GOVERNMENT OF THE DISTRICT OF COLUMBIA
DEPARTMENT OF TRANSPORTATION

MEMORANDUM

SUBJECT: BZA Case No. 18400A – Jewish Primary Day School, 6045 16th St. NW

Figure 2: On-Street Parking Study Area (Source: Applicant)

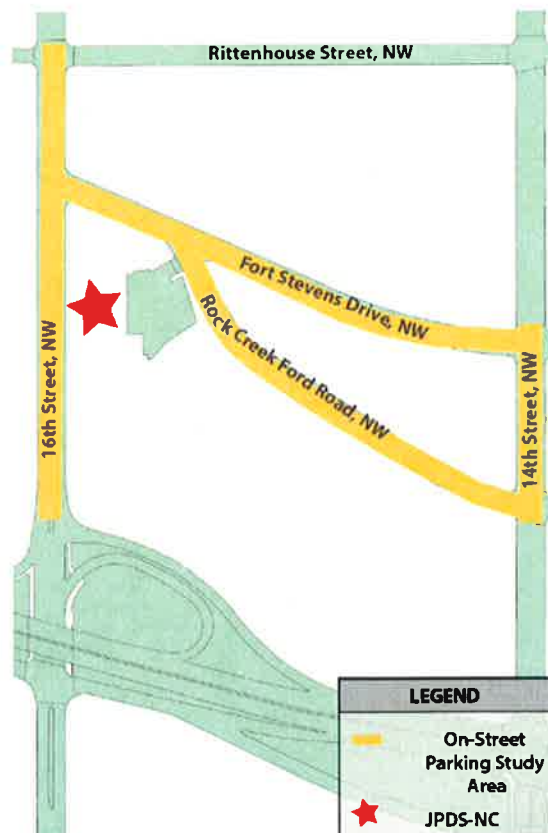
The Applicant conducted an on-street vehicle occupancy study on Wednesday, June 3, 2015 at 10:00 am and Tuesday, June 9, 2015 at 2:00 pm of the blocks immediately surrounding the site (see Figure 2). Parking peak for this residential area was presumed to be in the evening when the majority of residents are home and the school is closed. Of the 128 total parking spaces inventoried, 57% were utilized during the morning and 66% in the evening (see Figure 3). There were a total of 22 spaces available in the morning and 21 spaces in the afternoon that were unrestricted parking spaces. While a school zone will remove some of those unrestricted parking spaces, there is an adequate supply of on-street vehicle parking spaces to meet the school's daytime needs. Parking for occasional evening special events will be accommodated on-site – including the use of all 28 tandem spaces – and off-site through street parking, satellite parking at Ohr Kodesh Synagogue via shuttle service, and valet service to the golf course across 16th Street. Based on the provided number of on- and off-site parking spaces and availability of on-street parking, DDOT finds that the expected parking demand can be accommodated and supports the vehicle parking variance.

Figure 9: Future Vehicle Pick-Up Circulation and Maximum Queuing Capacity (Source: Applicant)

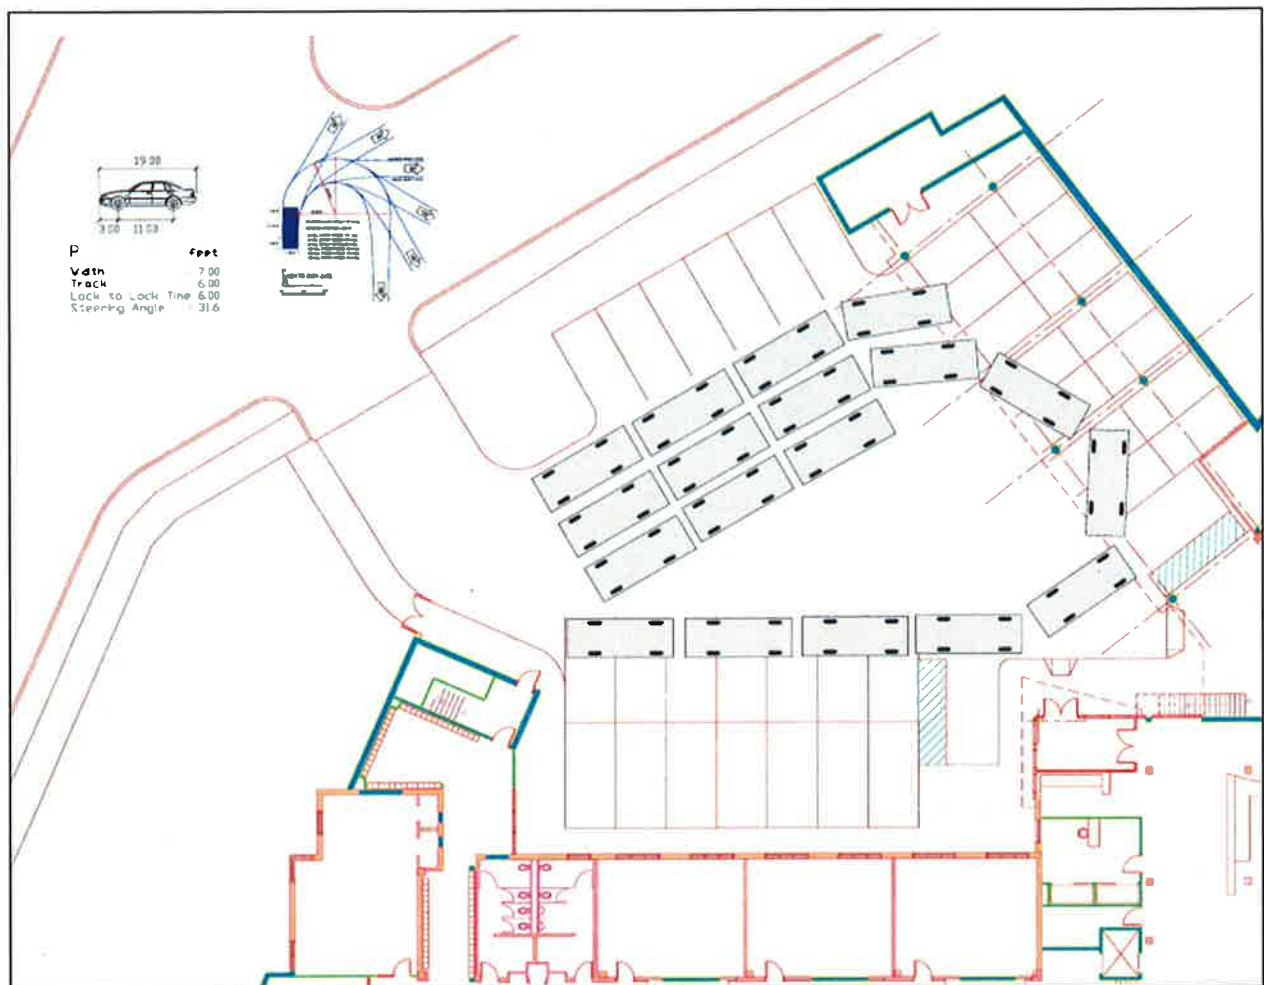
Field observations were conducted on Wednesday, June 3, 2015 from 6:30 AM to 9:30 AM and 2:30 PM to 6:30 PM. At that time, the Applicant observed two parent vehicles queued along Fort Stevens Drive at any one time during dismissal. According to the Applicant's counts for mode share, conducted when 188 students were enrolled, 53 students were driven alone and 44 students carpooled in the PM dismissal (see Figure 4) for a total of 75 vehicles. As the school reaches the proposed cap of 350 students (86% increase in population), that means an additional 65 cars would access the site if the mode split is maintained, exacerbating the off-site queue. The increased student capacity translates to 130 total new vehicle trips generated into and out of the site, which would be spread out over the several hours (or 143 total school PM peak hour trips, as seen in Figure 7). As a result of the building expansion and introducing an on-site sidewalk to connect the new school entrance at rear of the school to the public sidewalk along Rock Creek Ford Road, the on-site vehicle storage capacity is reduced from 20 vehicles to 18 vehicles, further adding to vehicle queuing on public streets (see Figure 9).

The proposed increased in student and staff enrollment will exacerbate the queue on public streets if not appropriately mitigated. The Applicant intends to stagger dismissal by 15 minutes to minimize the vehicle queue. Additionally, a school zone will also enable vehicles to temporarily stop to pick-up and drop-off students reducing vehicle queuing on- and off-site when buses are not queuing. The Applicant has proposed a Performance Monitoring Plan (PMP) as a means to address vehicle queuing on public streets during arrival and dismissal. A PMP gives the Applicant flexibility in managing site generated trips and vehicle queuing without having prescriptive criteria set forth by DDOT. However, the proposed PMP needs to be strengthened in order to provide certainty to DDOT that the proposed increase in student enrollment will not create queuing problems on the transportation network, and should problems arise, they will be addressed in a timely fashion (see PMP section below for more details).

- Conduct counts and provide a monitoring report twice per year (fall and spring semesters, not to coincide within a week before or after any extended school breaks) for two years beginning when the school reaches 275 enrolled students and again when the school reaches the proposed cap of 350 students to DDOT's Policy, Planning, and Sustainability Administration;

- Trip generation counts and queuing will need to be observed a minimum of 7:00 am to 9:30 am and 2:30 pm to 6:00 pm;
- Vehicle trip generation shall include all vehicle trips to the site, inclusive of vehicles traveling to the site but not entering the driveway;

- Establish a vehicle trip generation cap of 271 total trips (ins and outs) during the AM peak hour and 135 total trips during the school PM peak hour (not commuter PM peak hour);

- Vehicle queuing for pick-up and drop-off must be within the property line. Vehicle queuing cannot extend to block the sidewalk across the driveway or onto any public streets;
